**ST. TAMMANY PARISH**

**Addendum No.: 3**

**Bid#: 24-10-2**

**Project Name: Highway LA-21 Lift Station**

SITE LAYOUT PLAN

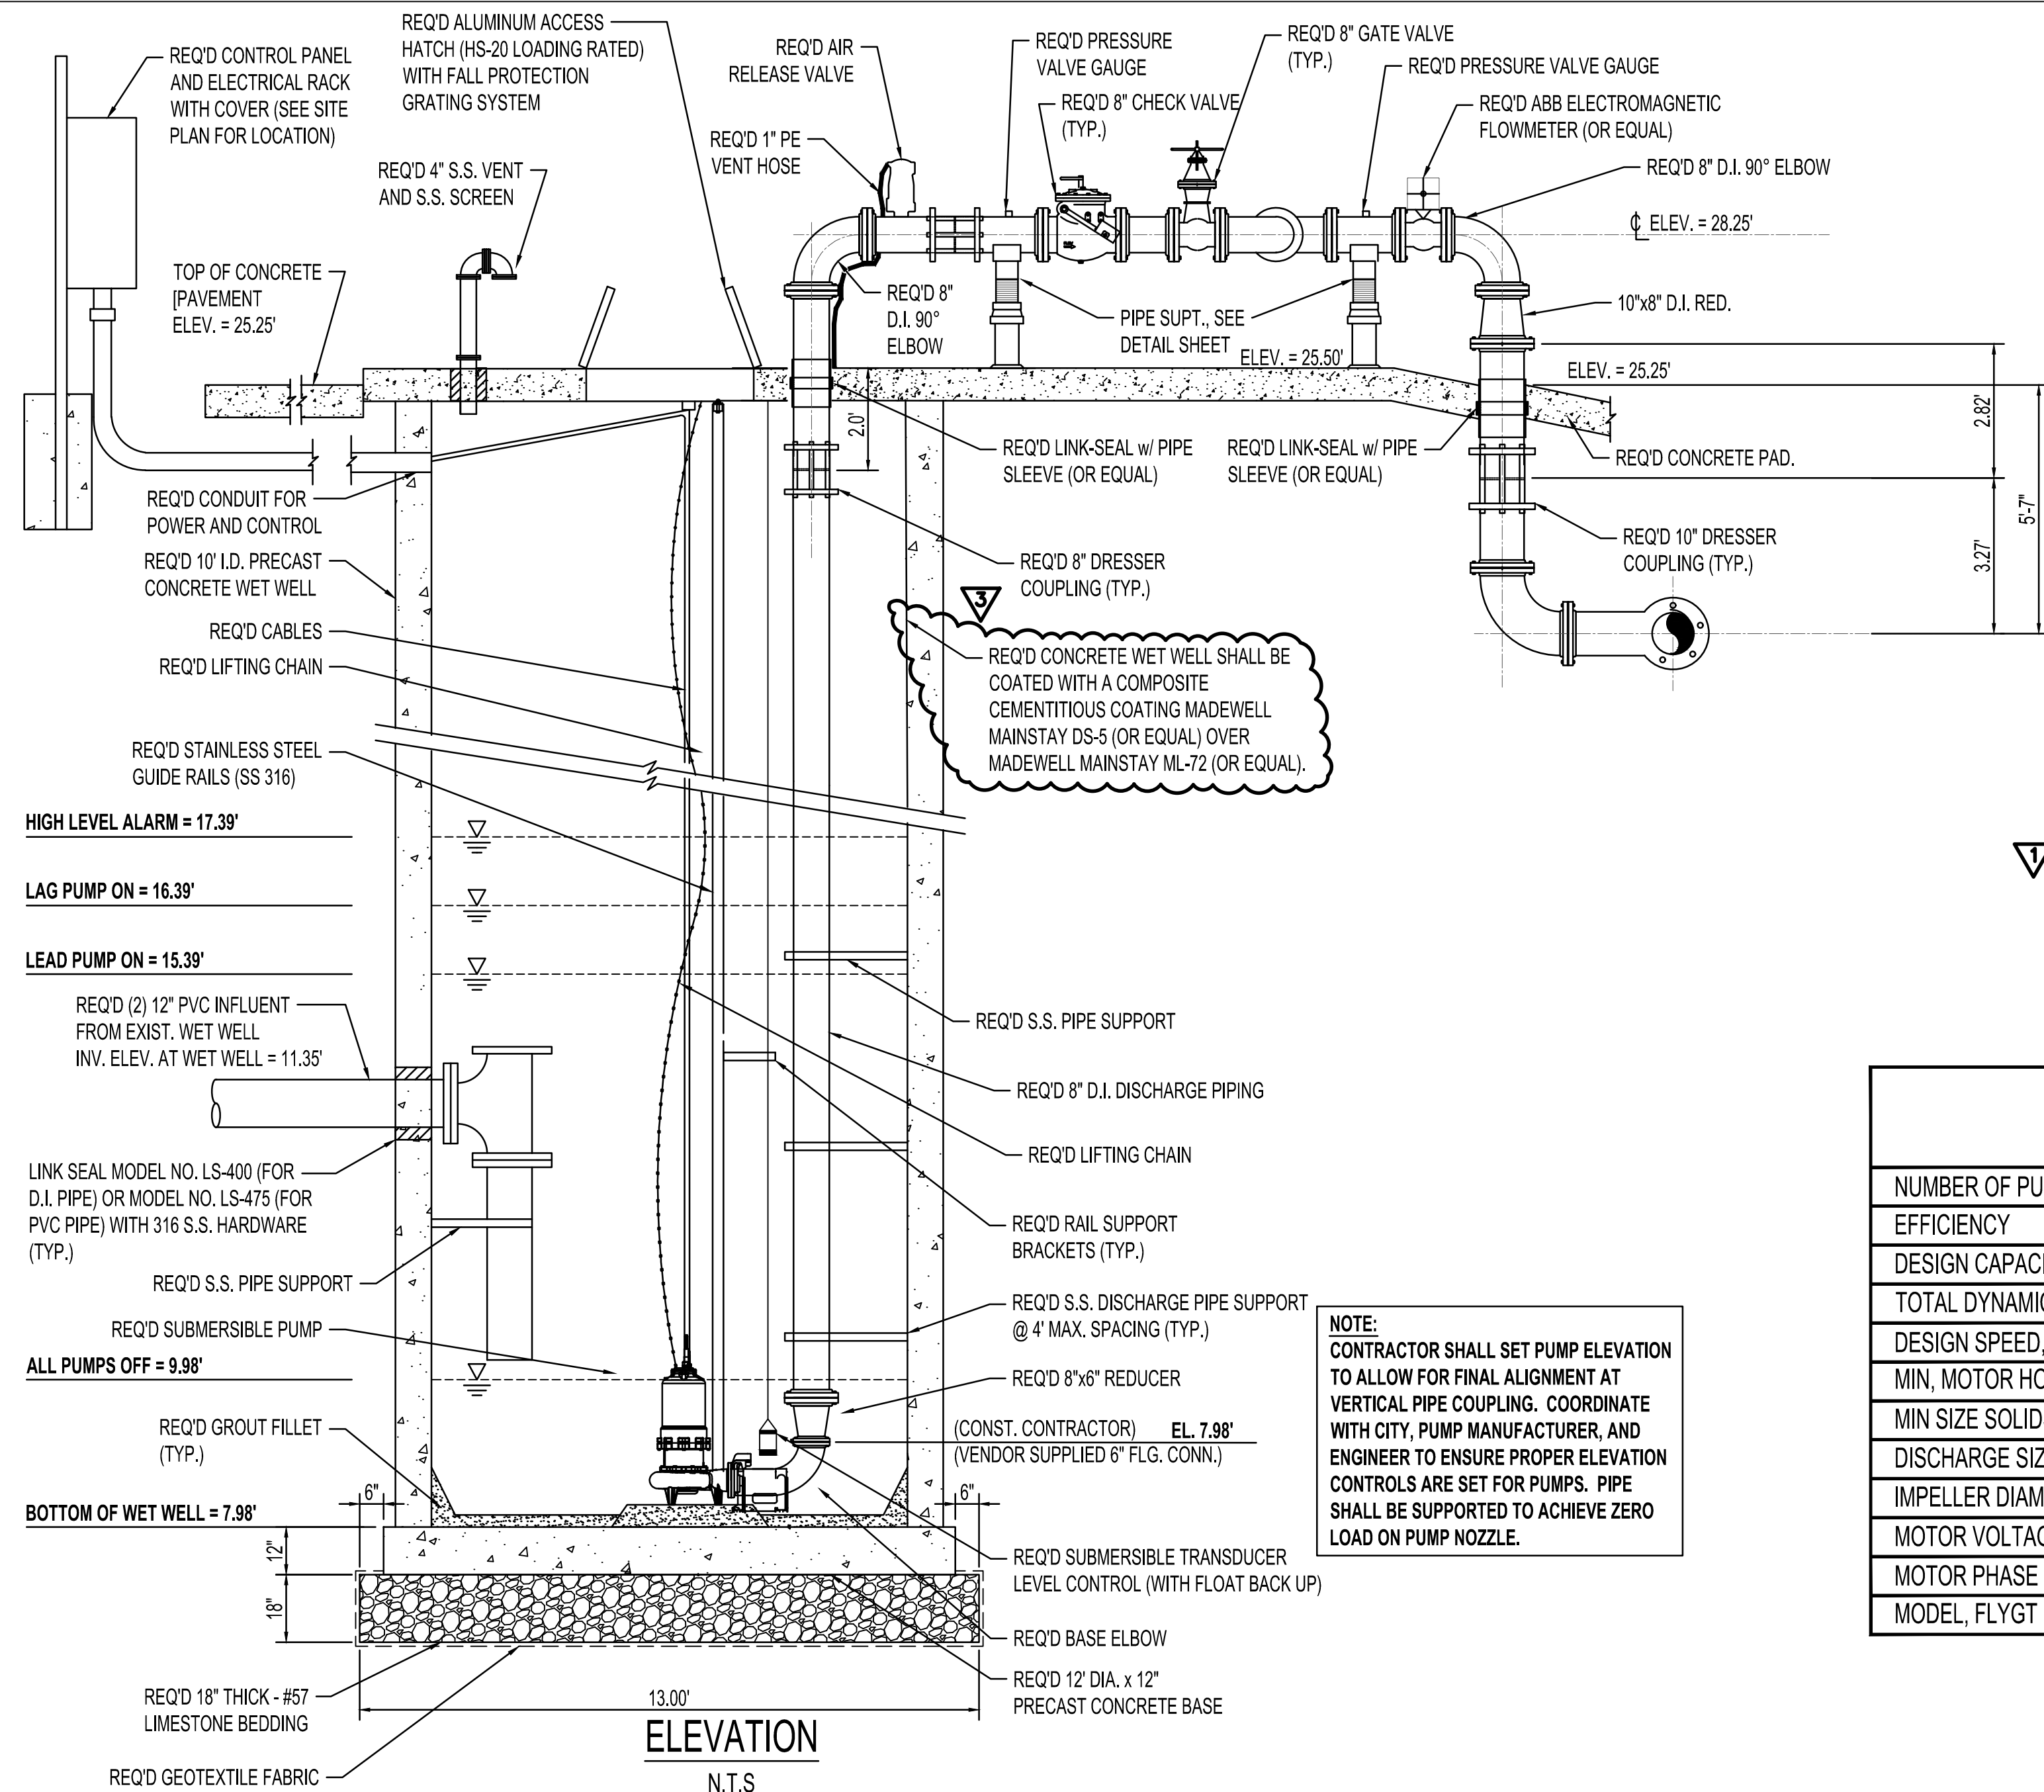
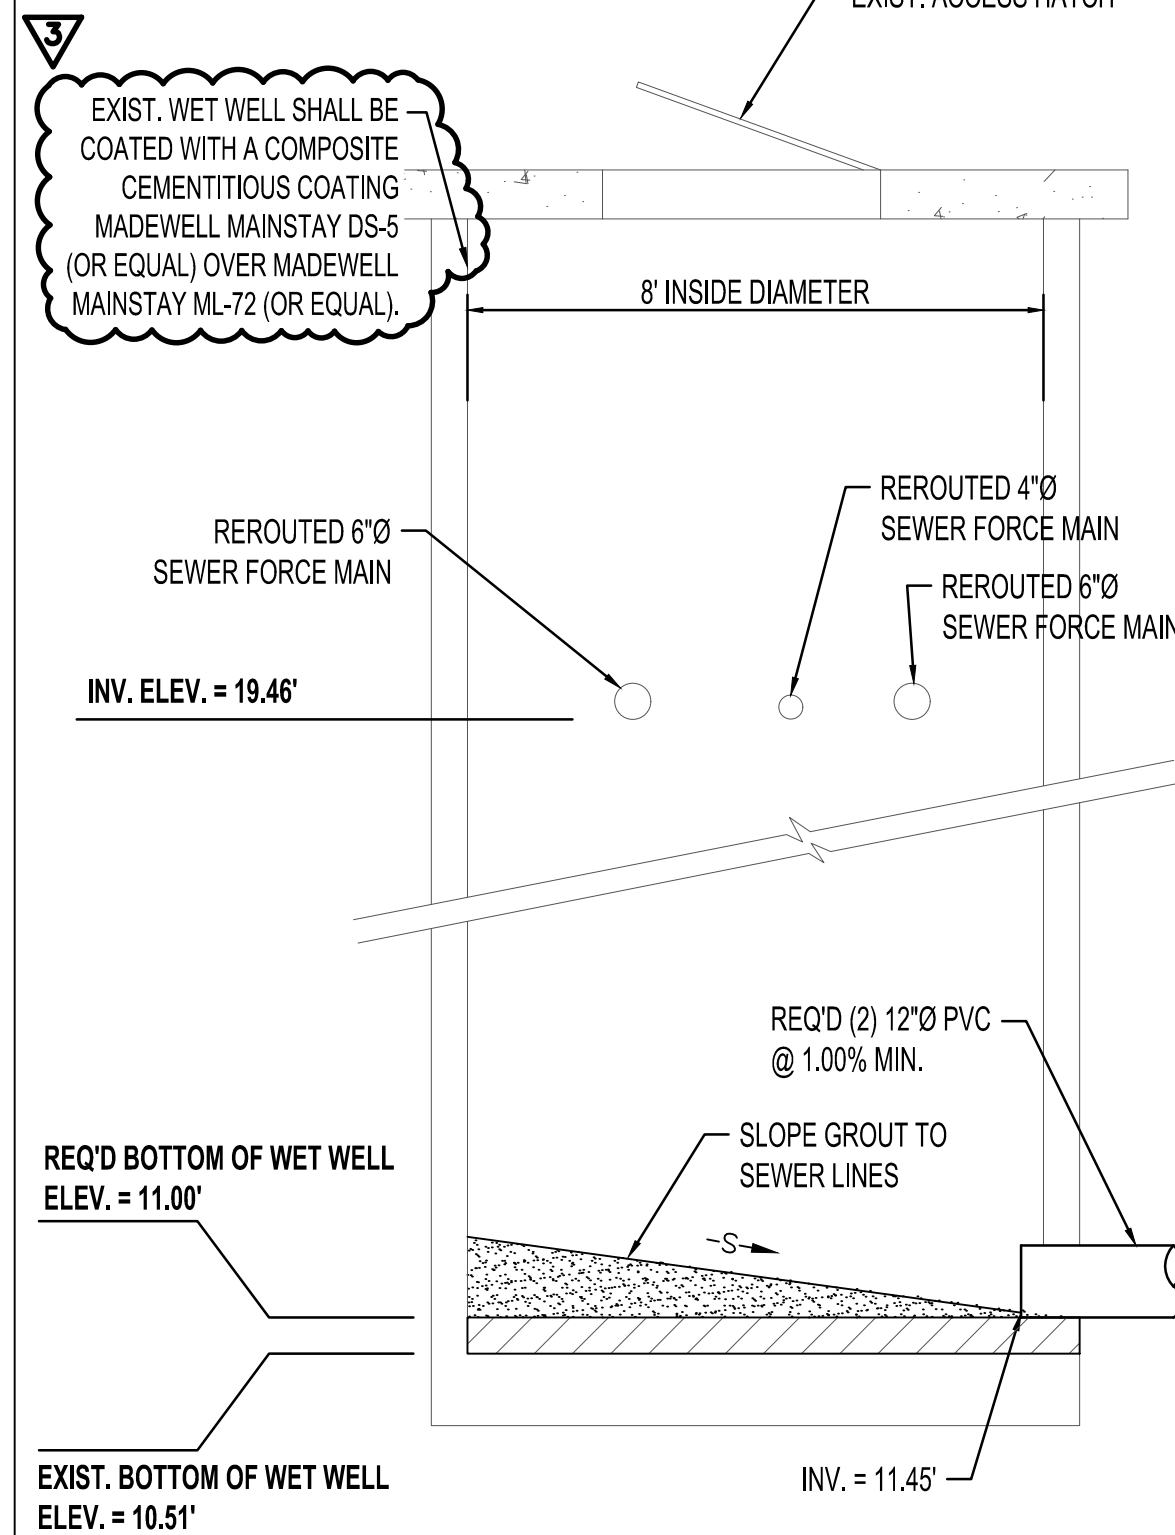
**Drawing Revision: Sheet 10 – Site Layout Plan has been revised to include a note for the furnishment and installation of the electric chain joist. See Sheet 10 – Site Layout Plan for more details, in this Addendum below.**

**Drawing Revision: Sheet 10 – Site Layout Plan has been revised to reflect the revised servitude boundary lines. See Sheet 10 – Site Layout Plan for more details, in this Addendum below.**

- Add Note 3 to ‘Notes’:

- Req’d Right of Use Servitude Area has been revised from +/- 0.02 AC to +/- 0.038 AC. The note and associated servitude linework has been revised accordingly.

“Contractor shall furnish and install an 1-ton electric chain hoist and controls (CM Lodestar or Approved Equal). This work shall be included in Item 133 – Freestanding Jib Crane (1 Ton) at no direct pay’

- NOTES**
- PRIOR TO BEGINNING WORK, CONTRACTOR SHALL CONFIRM SIZE AND LOCATION OF EXISTING SEWER FORCE MAIN AND WATER LINE. IF INCONSISTENCIES OCCUR BETWEEN PLANS AND FIELD VERIFICATIONS, CONTRACTOR SHALL COORDINATE WITH PARISH PRIOR TO CONSTRUCTION.
  - SEE DETAIL SHEETS FOR REQUIRED REINFORCEMENT INFORMATION ON JIB CRANE AND GENERATOR PADS.
  - CONTRACTOR SHALL FURNISH AND INSTALL AN 1-TON ELECTRIC CHAIN JOIST AND CONTROLS (CM LODESTAR OR APPROVED EQUAL). THIS WORK SHALL BE INCLUDED IN ITEM 133 - FREESTANDING JIB CRANE (1 TON) AT NO DIRECT PAY.

**LIFT STATION  
 PLAN AND ELEVATION**

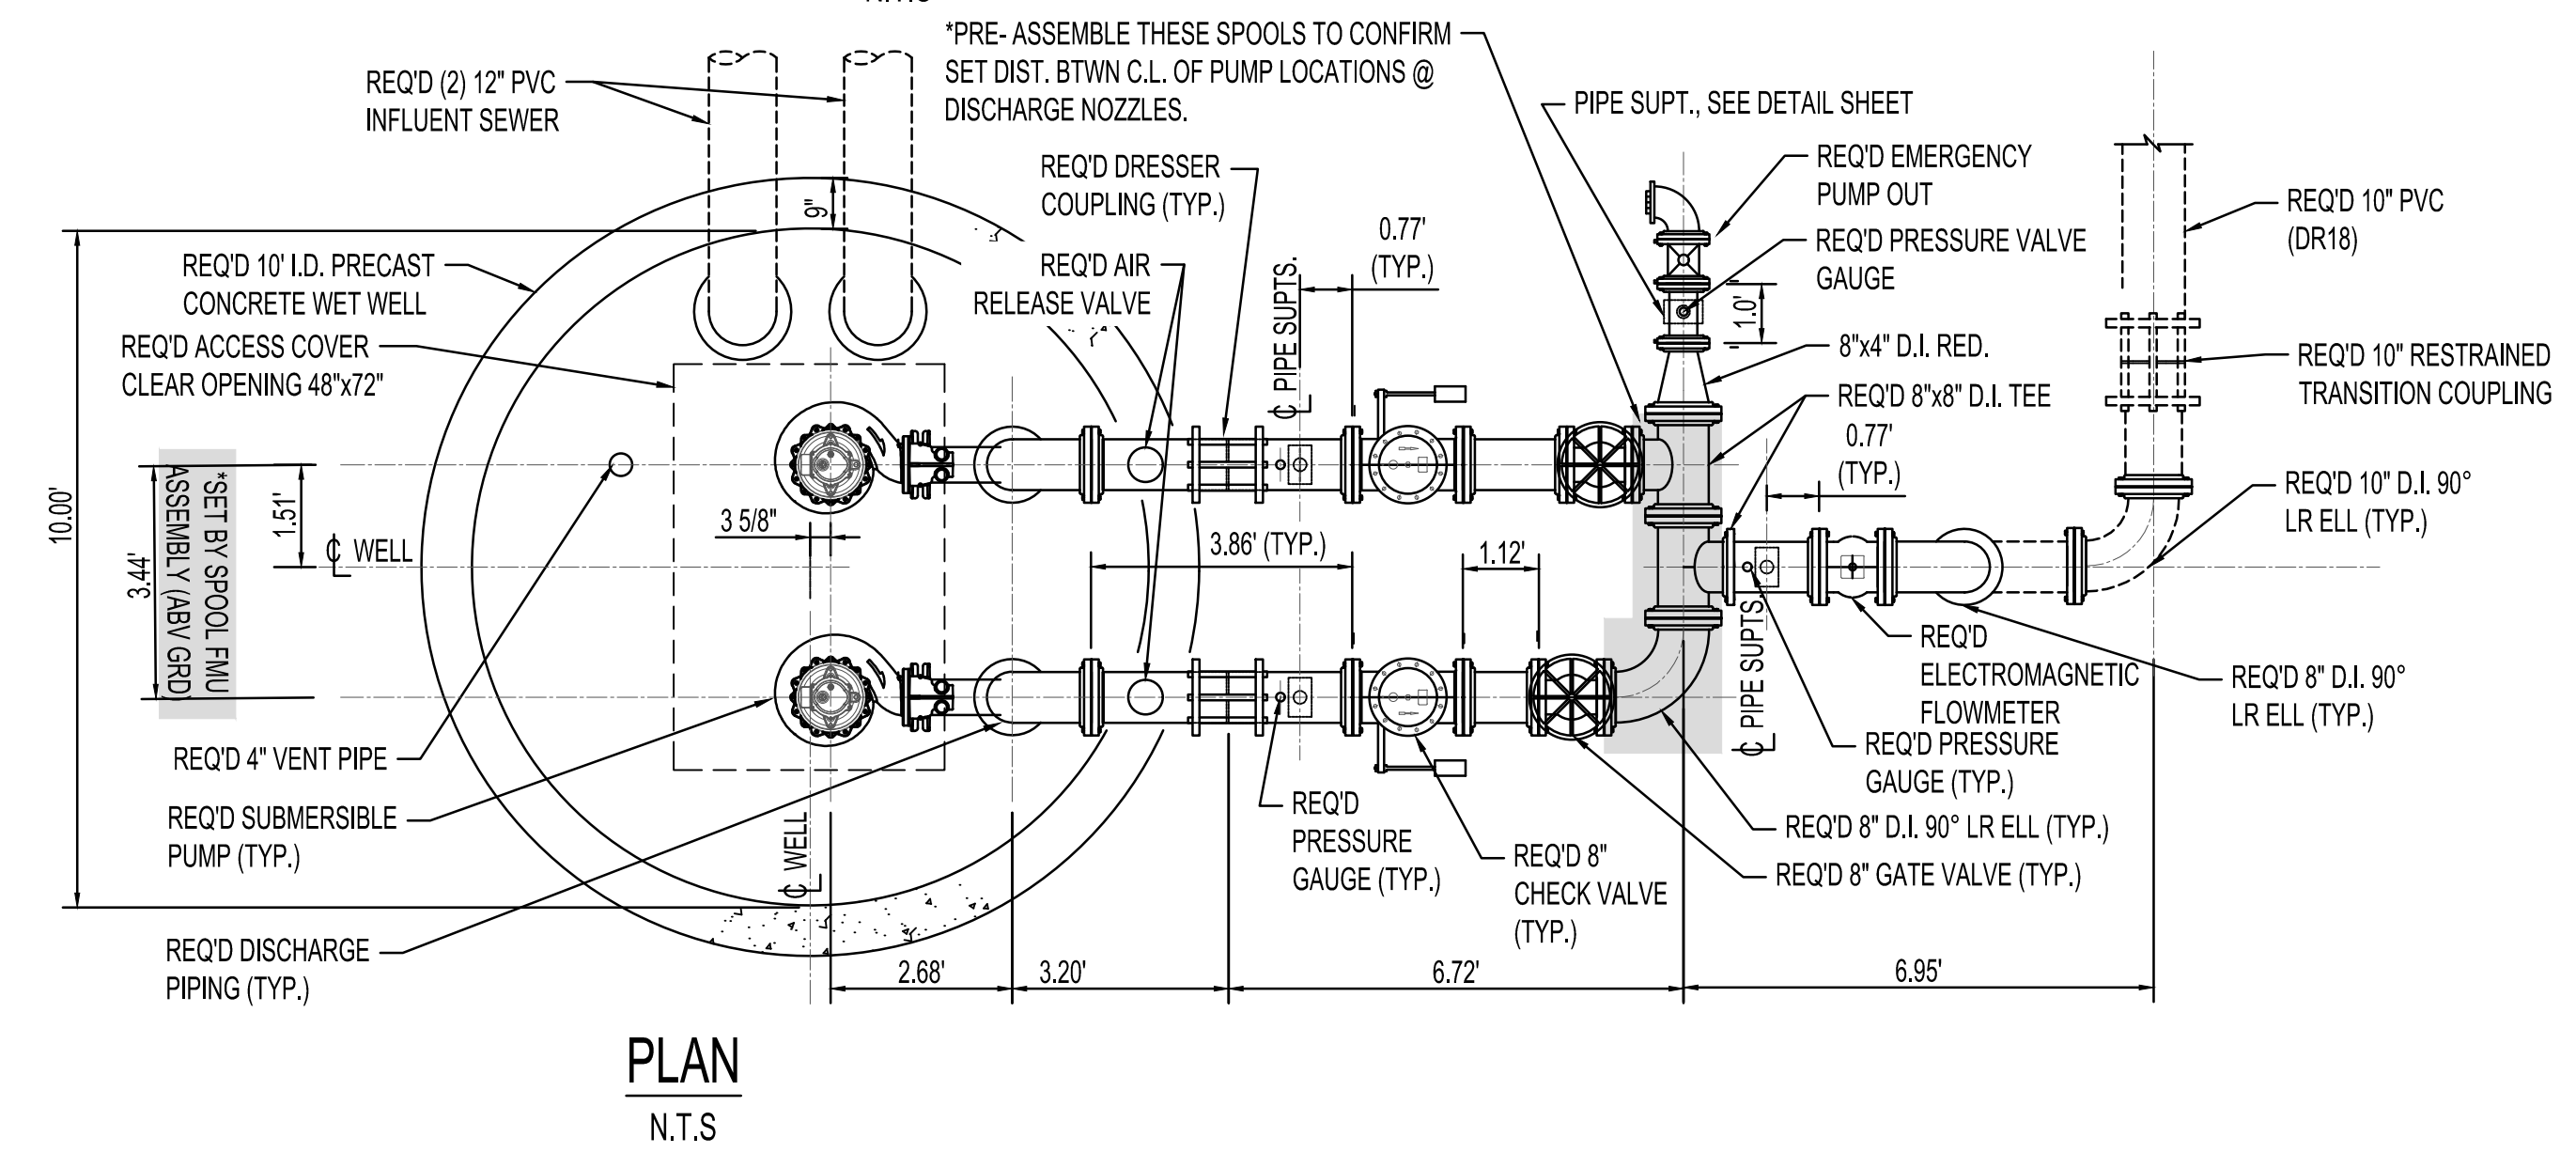
**Drawing Revision: Sheet 12 – Lift Station Plan and Elevation has been revised to include notes for the required coatings on the existing and proposed concrete wet**

- Add Call to ‘Exist. Wet Well Elevation’ view:

- Add Call to ‘Elevation’ view:

“Exist. wet well shall be coated with a composite cementitious coating Madewell Mainstay DS-5 (or equal) over Madewell Mainstay ML-72 (or equal.)”

“Req’d concrete. wet well shall be coated with a composite cementitious coating Madewell Mainstay DS-5 (or equal) over Madewell Mainstay ML-72 (or equal.)”
